#### CONSENT & MINOR VARIANCE APPLICATION City of Ottawa | Ville d'Otta CON MENTS TO THE COMMITTEE OF ADJUSTMENT Comité de dérogation PANEL 2 PLANNING\_DEVELOPMENT AND BUILDING SERVICES DEPARTMENT

## **DEPARTMENT COMMENTS**

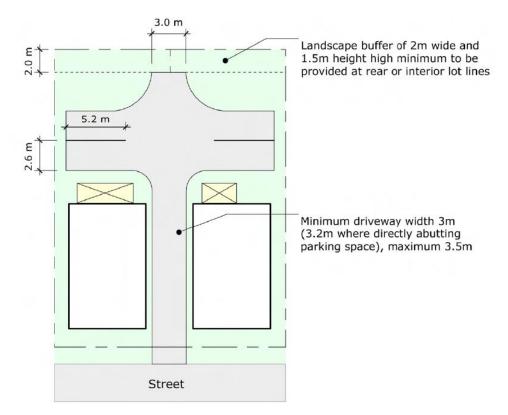
The six proposed parking spaces in the rear yard do not appear to be functional. Provide swept path analysis (AutoTURN) to demonstrate that cars can maneuver in and out of the spaces. Recommend removing two of the six spaces and providing a "hammerhead" turning space as demonstrated in the new Zoning By-Law, see below:
